Subject: Subdivision Application No. 20190007
Roslyn Swim Club Lot Consolidation and Parking Lot Expansion
838 Spruce Avenue

LAND DEVELOPMENT PLAN
ROSLYN SWIM CLUB
 WEST GOSHEN TOWNSHIP CHESTER COUNTY, PA.
 Edward B. Walsh & Associates, Inc.
 CIVIL ENGINEERS & SURVEYORS
 Lionville Professional Center
 125 Douthett Forge Road
 Exton, Pennsylvania 19341
 Phone (610) 903-0060
 Fax (610) 903-0080
 Project- 3525
 Date- 9-27-19
 Scale- 1" = 20'
 Drawn- C.E.
 Checked- AE
 Sheet- 5 OF 10
 Plotted: 5/21/2020 File: F:\JBA\3525\FPS\3525-B3.pro

Re: Final Subdivision and Land Development - Roslyn Swim Club
West Goshen Township – SD-11-19-16164 and LD-11-19-16166

Site Plan Detail, Sheet 1: Final Subdivision - Roslyn Swim Club

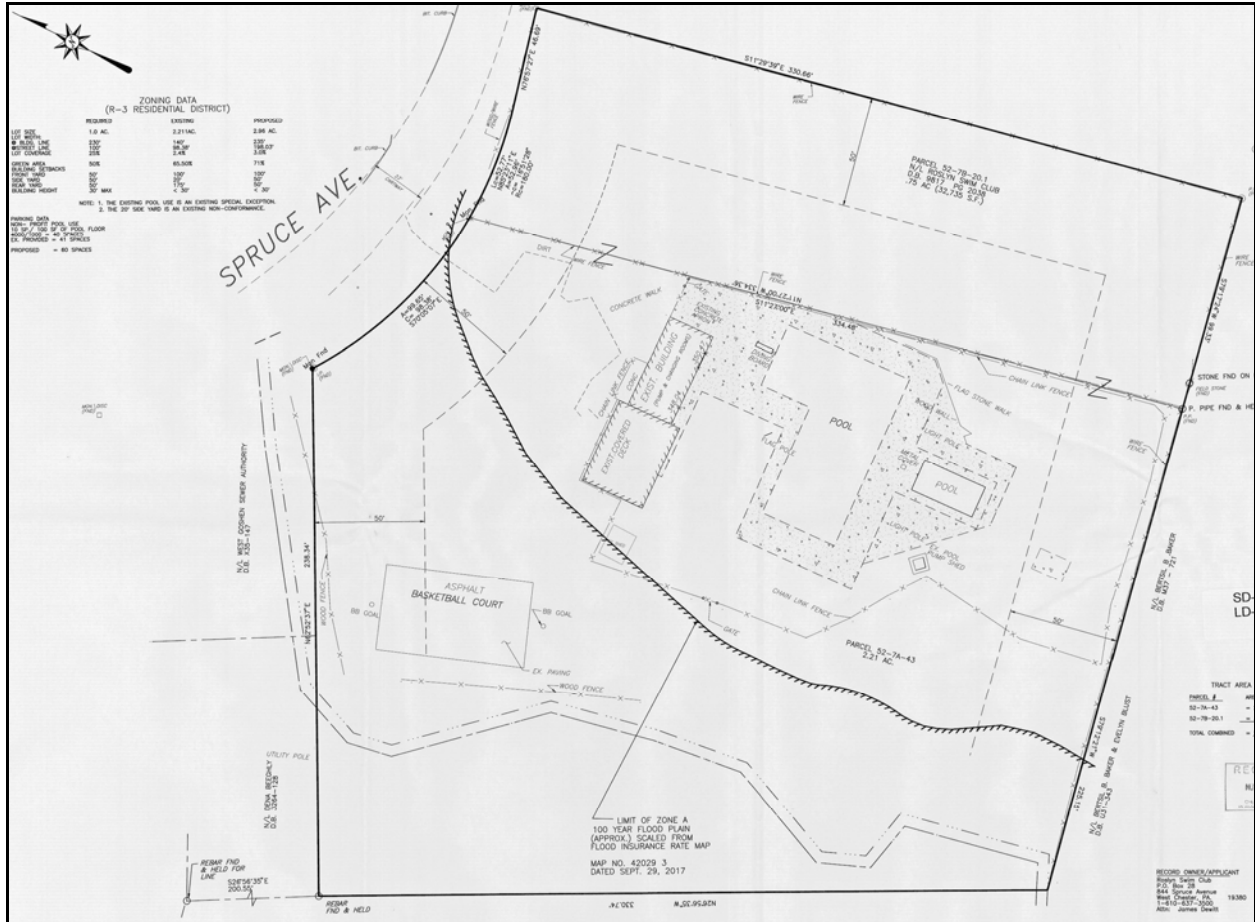
3. The 2015 Chester County Natural Heritage Inventory, which is available online at chescoplanning.org/natresources/ResourcesChesco.cfm, indicates the project site is located within the core habitat of the Robert B. Gordon Natural Heritage Area (NHA) included in the Pennsylvania Natural Diversity Index (PNDI). **Landscapes3** recognizes NHA core habitat areas as natural resource priority protection areas. Protecting natural areas helps ensure that the critical functions these areas provide will not diminish due to development. Development on this portion of the site could be detrimental to the NHA species population, if they exist on the site. We recommend that the applicant and Township contact the PA Department of Conservation and Natural Resources, Pennsylvania Natural Heritage Program (<http://www.naturalheritage.state.pa.us> or RA-HeritageReview@pa.gov) for further information on this matter. We also note that this NHA is administrated in collaboration with West Chester University’s Office of Sustainability, as identified online at: www.wcupa.edu/gordonNaturalArea/default.aspx.

4. The site contains land within the 100 year floodplain (an unnamed tributary to Plum Run traverses the western portion of the project site). The Federal Emergency Management Agency and Pennsylvania Department of Environmental Protection regulate filling or development in the floodplain. Development within a floodplain can increase the magnitude and frequency of normally minor floods, and present health and safety problems. The applicant should contact both of these agencies to determine if the proposed development activity will require a permit. The Township should request documentation of these contacts or permit(s) before approving the plan.
